Bureau of Environmental Health  
7178 Columbia Gateway Drive, Columbia MD 21046  
(410) 313-2640 Fax (410) 313-2648  
TDD (410) 313-2323 Toll Free 1-866-313-6300  
website: www.hchealth.org

**RE: Variance Approval**  
6437 Lochridge Road  
Columbia, MD 21044

This letter is being issued as follow up to the Health Department's verbal approval of your waiver request. The Department of Health has received your variance request received on July 20, 2009 for the above referenced property. This agency will grant **approval** of the waiver to the required Percolation Certification Plan as required by the *Howard County Code, Subtitle 8, Section 3.805*. The waiver has been approved on the basis that the proposed shed will not impact on site.

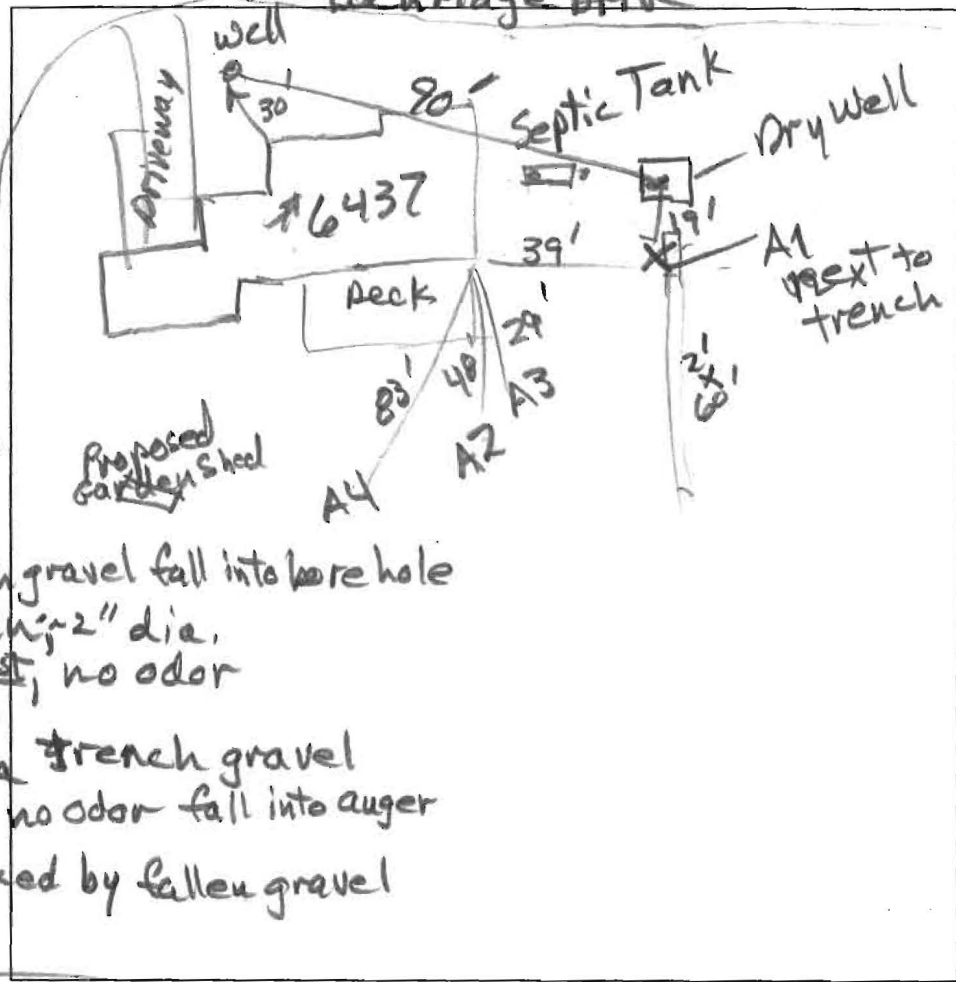
Verbal ok  
7/28/09  
SS

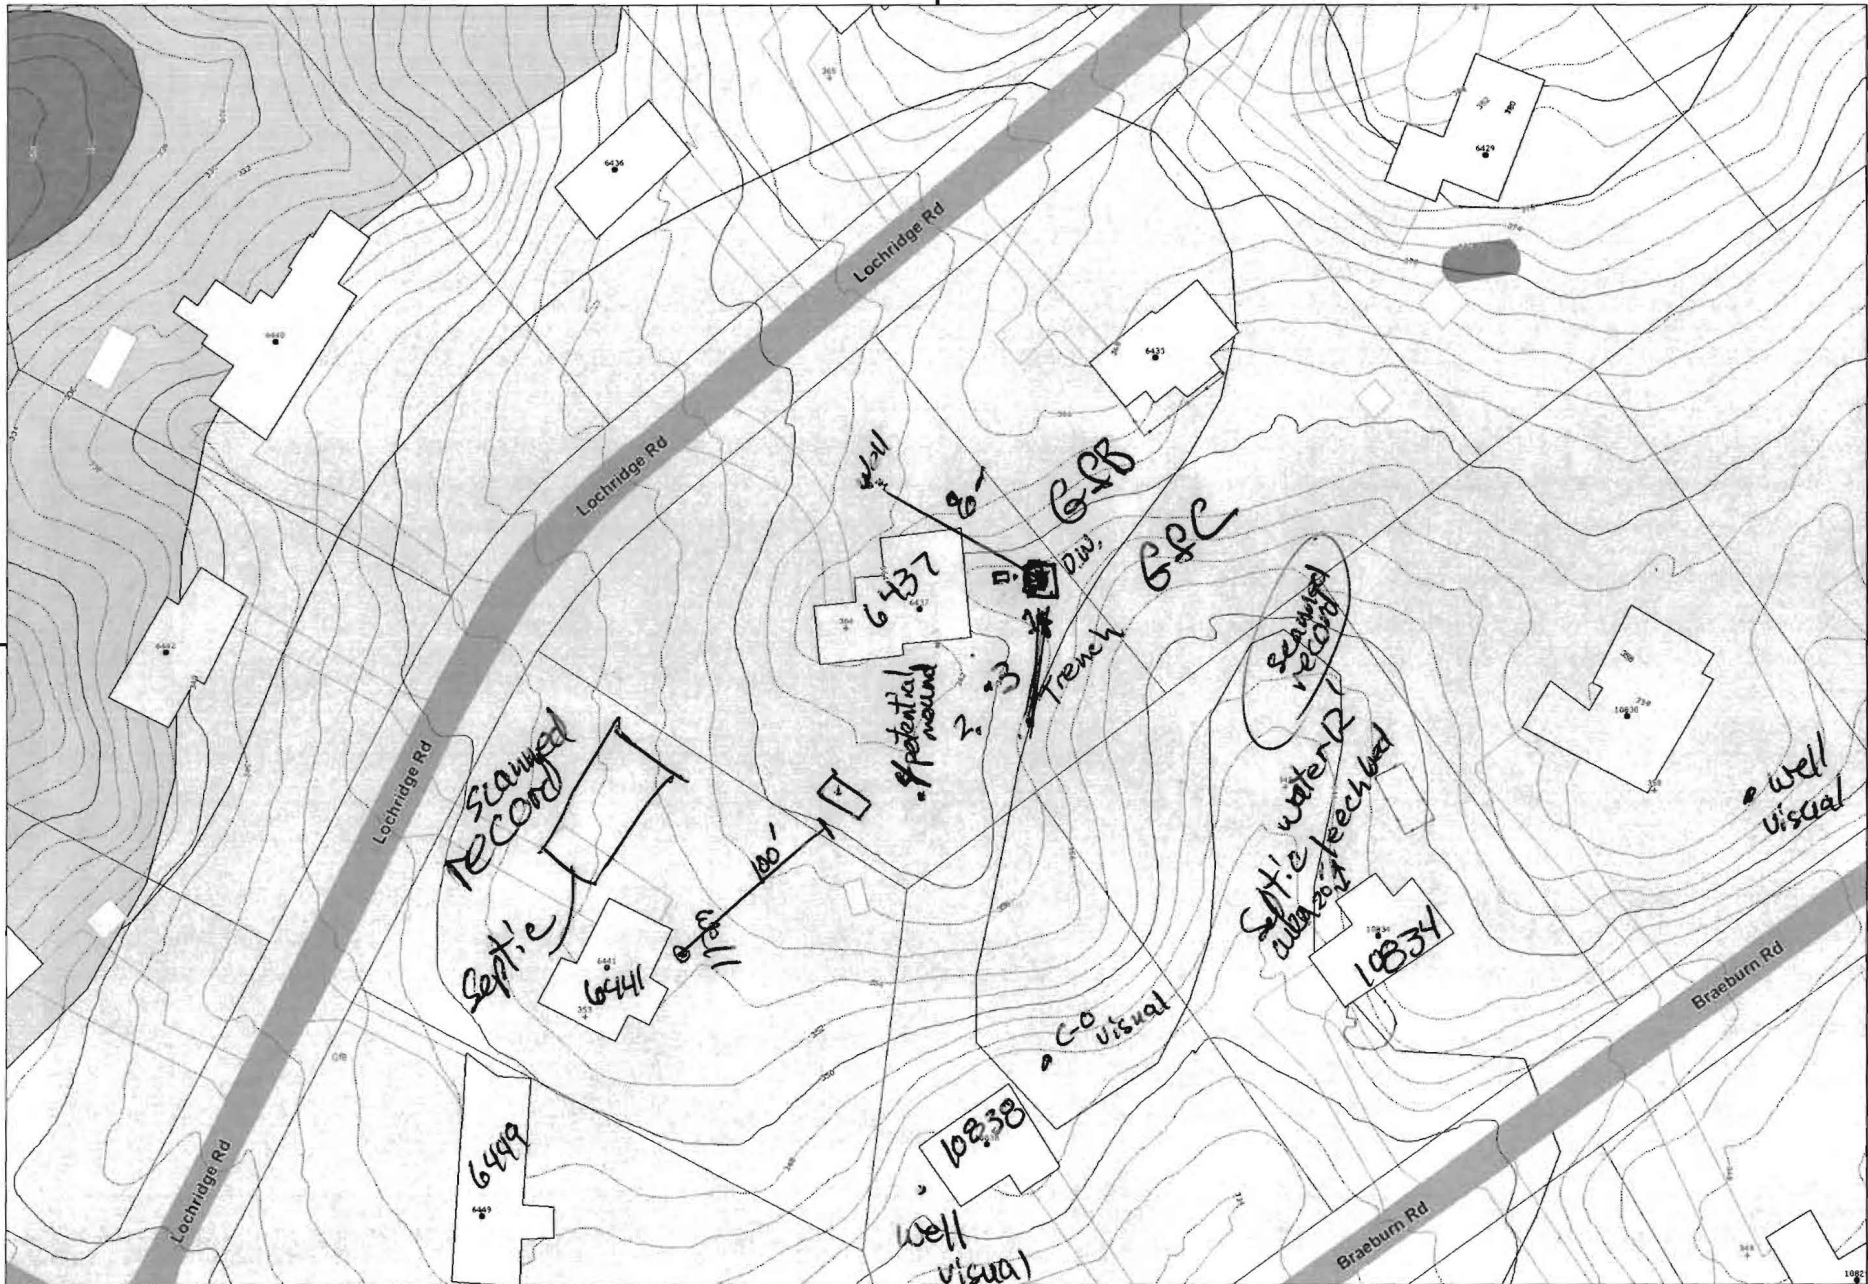
DATE	TEST #	DEPTH	START	BREAK 1" DROP	STOP 2" DROP	TIME OF 2nd INCH	P/F/H
	A1	9'	Visual		probably edge of trench		
	A3	10.5'	Visual		good side all 2.5 to 6.5 4' buffer to 10.5	P	
	A4	2.2'	Potential		sand mound

REMARKS A4, potential mound location; A3, good for deep system  
 SANITARIAN RB BACKHOE \_\_\_\_\_ OTHERS \_\_\_\_\_  
 TEST HOLES USED IN SDA \_\_\_\_\_ AVG. PERC TIME \_\_\_\_\_ SQ. FT/BR \_\_\_\_\_  
 TRENCH WIDTH \_\_\_\_\_ INLET DEPTH \_\_\_\_\_ MAX. BOT DEPTH \_\_\_\_\_ EFFECTIVE SW \_\_\_\_\_

LOCATION DIAGRAM

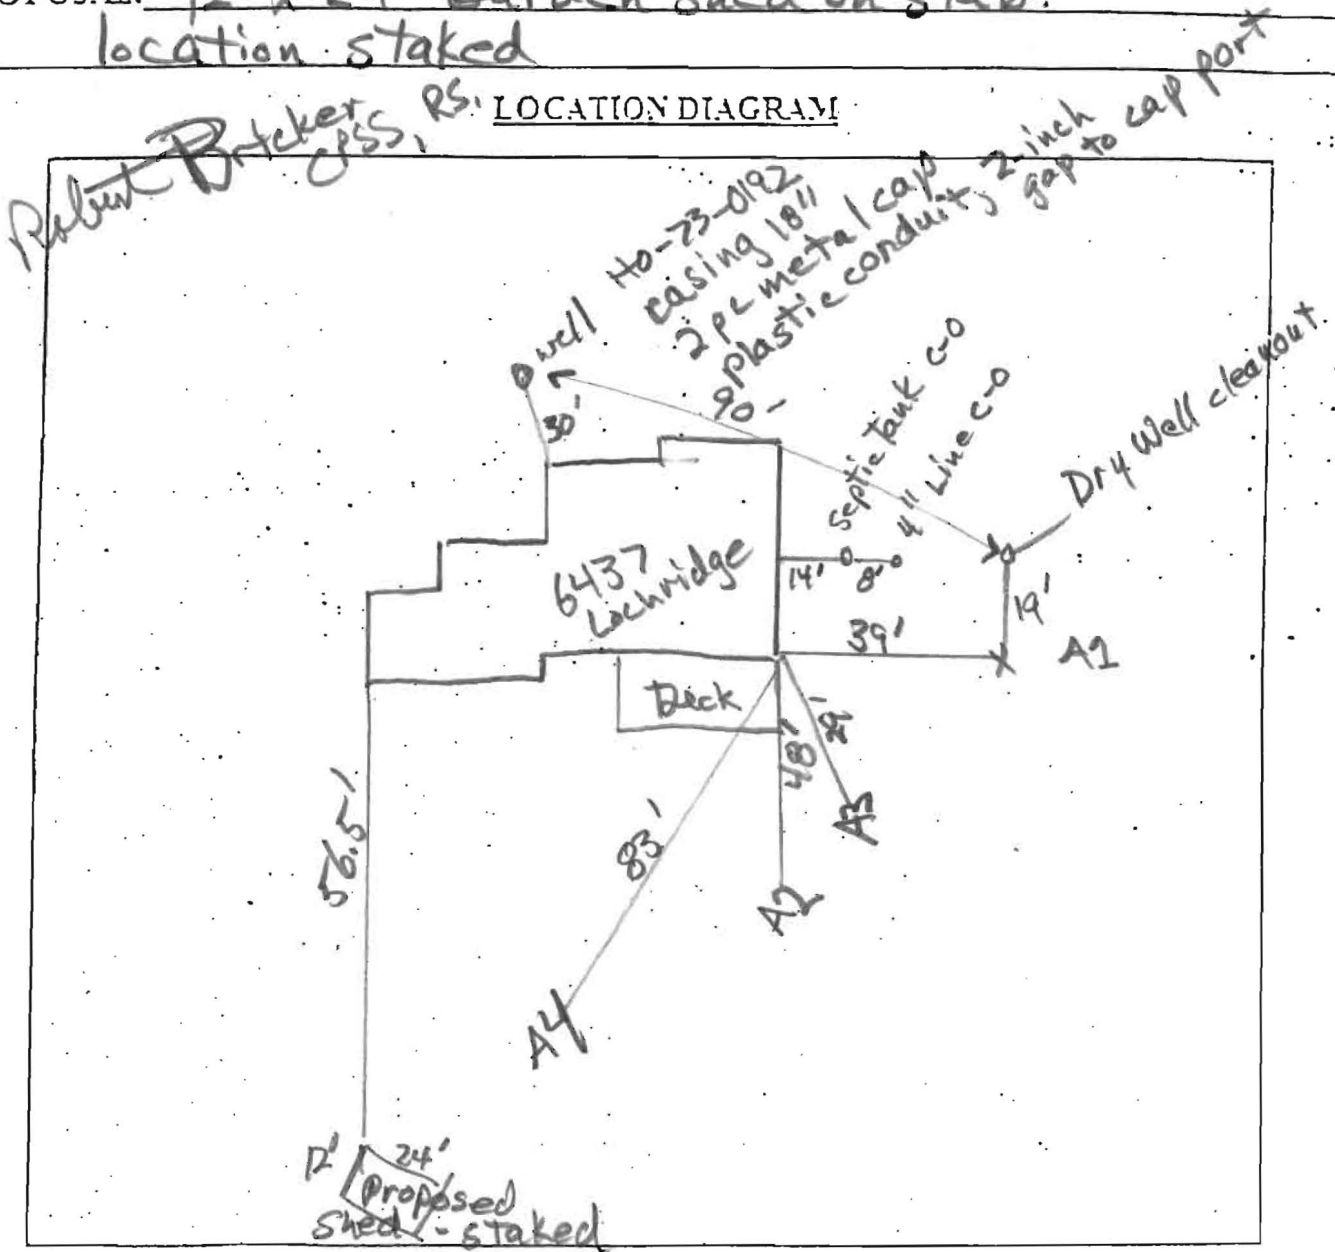
COMMENTS: Septic Tank: bottom of clean-out pipe, 3'; scum layer 4'4"  
Line Clean out 4'4" to Pipe Invert.  
Dry Well: bottom of clean out, 4'; solution level, 6'  
A1: Trench gravel (2 inch dia.) falling into bare hole; gravel clean
